STAFF REPORT

Case No. 0321-01

THE PORTSIDE SUBDIVISION PLANNED UNIT DEVELOPMENT (PUD)

TECHNICAL REVIEW COMMITTEE (TRC) PLAT REVIEW COMMENTS

THE PORTSIDE P.U.D.
MASTER SITE PLAN
EXHIBIT 2

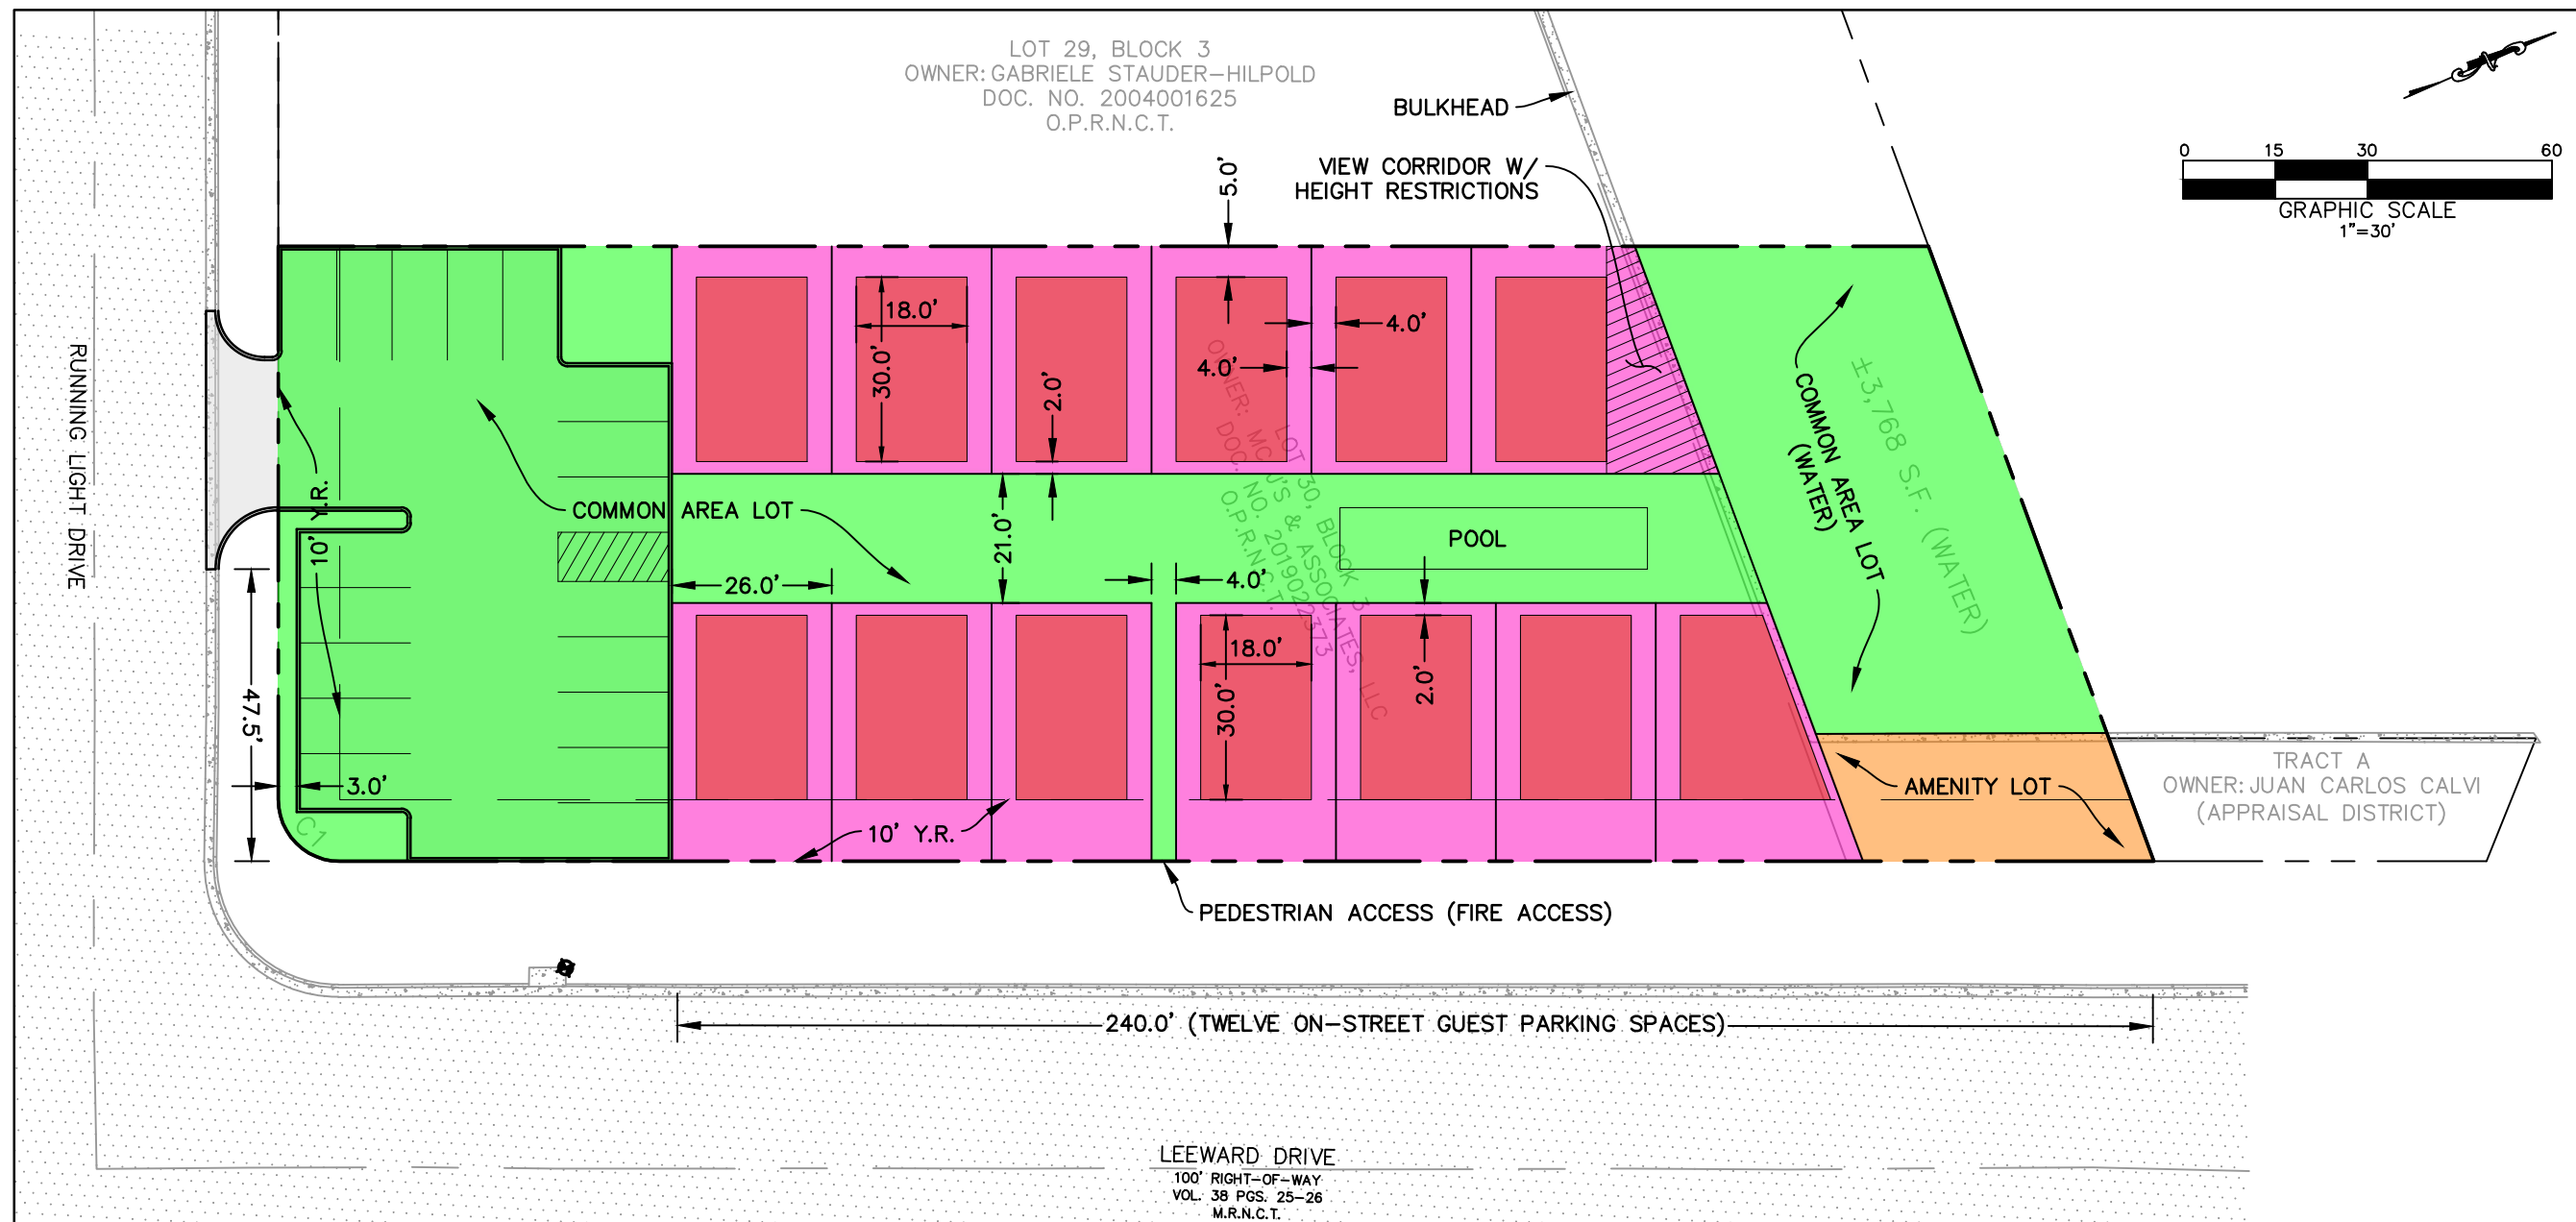
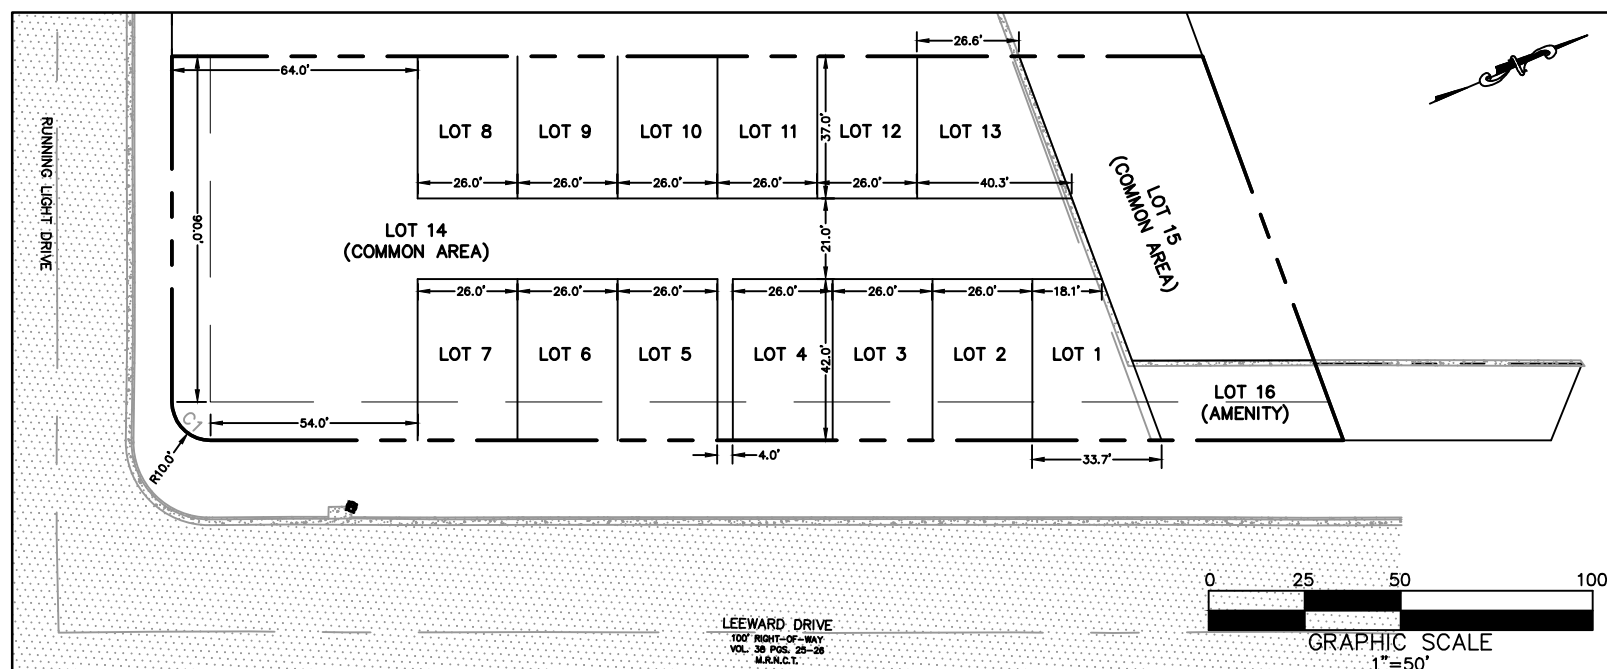
ZONING						
No.	Sheet	Comment	Applicant Response	Staff Resolution	Applicant Response	Staff Resolution
1	PUD	Sidewalks shall be constructed along Running Light Drive and Leeward Drive. This comment will be also cited at the platting stage.	To be addressed at platting stage

PLANNING/Environment & Strategic Initiatives (ESI)						
No.	Sheet	Comment	Applicant Response	Staff Resolution	Applicant Response	Staff Resolution
1	PUD	Was this lot(s) granted a sidewalk waiver in the past?; driveway should take access from Running Light and should be further from the intersection; will there be an HOA to maintain; guest parking on Running Light rather than Leeward?; will 3 golf cart parking spaces be enough for 13 units, which spaces are they on the drawing?; will landscaping or screening walls be used as a screen for the parking lot?; show on-street parking guest spaces provided.	No previous sidewalk waiver to our knowledge; Driveway access relocated to Running Light furthest possible from intersection; Yes there will be an HOA, Guest parking allowed on both leeward and Running Light, but Leeward used for parking tabulation due to larger frontage; Golf cart spaces relocated; landscaping and screening proposed between parking lot and public sidewalk; on-street parking area delineated on Master Site Plan.

UTILITIES ENGINEERING						
No.	Sheet	Comment	Applicant Response	Staff Resolution	Applicant Response	Staff Resolution
1	PUD	Point of Notice – It appears that an insufficient amount of water flow for fire protection is available at this location for this development, and improvements may be required if platted.	Assume this comment to be informational. Public water main construction proposed with platting

1		Proposed driveway access to a public City Street shall conform to access management standards outlined in Article 7 of the UDC. Review the driveway as it is to close to the intersection as generally you need a buffer, so northbound vehicles can make the left turn passing the intersection and not block the intersection.	Driveway access revised.			
---	--	--	--------------------------	--	--	--

No.	Sheet	Comment	Applicant Response	Staff Resolution	Applicant Response	Staff Resolution
1	PUD	Water Distribution Standards: If the property use is commercial, the fire flow requirements shall be a minimum of 1,500 GPM at 20 PSI residual. With hydrant spacing every 300 feet. If the property use is residential, the fire flow requirements shall be a minimum of 750 GPM with 20 psi residual. With hydrant spacing every 600 feet. The requirement for each shall be resolved at the Development Service or Building phase of the project. Exception: For buildings equipped with an approved automatic sprinkler system, the distance requirement shall	Noted. Property use to be residential.			
2	PUD	D102.1 Access and loading. Facilities, buildings, or portions of buildings hereafter constructed shall be accessible to fire department apparatus by way of an approved fire apparatus access road with an asphalt, concrete or other approved driving surface capable of supporting the imposed load of fire apparatus weighing at least 75,000 pounds.	Noted.

3	PUD	503.2.1 Dimensions. Fire apparatus access roads shall have an unobstructed width of not less than 20 feet, exclusive of shoulders and an unobstructed vertical clearance of not less than 13 feet 6 inches. Note: the entry point will require fire department access.	Noted.			
4	PUD	503.4 Obstruction of fire apparatus access roads. Fire apparatus access roads shall not be obstructed in any manner, including the parking of vehicles.	Noted.			
5	PUD	503.3 Marking: Where required by the fire code official, approved signs, or other approved notices the include the words NO PARKING-FIRE LANE shall be provided for fire apparatus access roads to identify such roads to prohibit the obstruction thereof. The designation of a fire lane can be marked with conspicuous signs which have the words: "Fire Lane-No Parking" at 50-foot intervals. In lieu of signs, fire lanes may be marked along curbing with the wording, "Fire Lane-No Parking" at 15-foot intervals.	Noted.

6	PUD	<p>Development of the property will require further Development Services review. Note: The minimum separation distance between cottages is 10 feet. Due to the proximity of the cottages, Development Services may not approve of this configuration.</p> <p>Note: The side gate on Leeward St. will allow 150 feet to farthest point of the cottages toward the dock and will be considered suitable as an access point for firefighting efforts. If the gate is secured, a Knox Padlock will be required.</p> <p>Note: If the dock is constructed with the capability for</p>	<p>Review of proposed building placement is required at this stage as layout is tied to PUD conditions. Cottages are proposed with 8-foot separation in accordance with UDC 4.7.11. Construction will comply with International Residential Code and current fire code as required by City.</p>			
---	-----	---	---	--	--	--

AEP-DISTRIBUTION						
No.	Sheet	Comment	Applicant Response	Staff Resolution	Applicant Response	Staff Resolution
1	PUD	AEP is requesting the 10YR to be a 10YR/EE off of Running Light	To be addressed at platting stage.
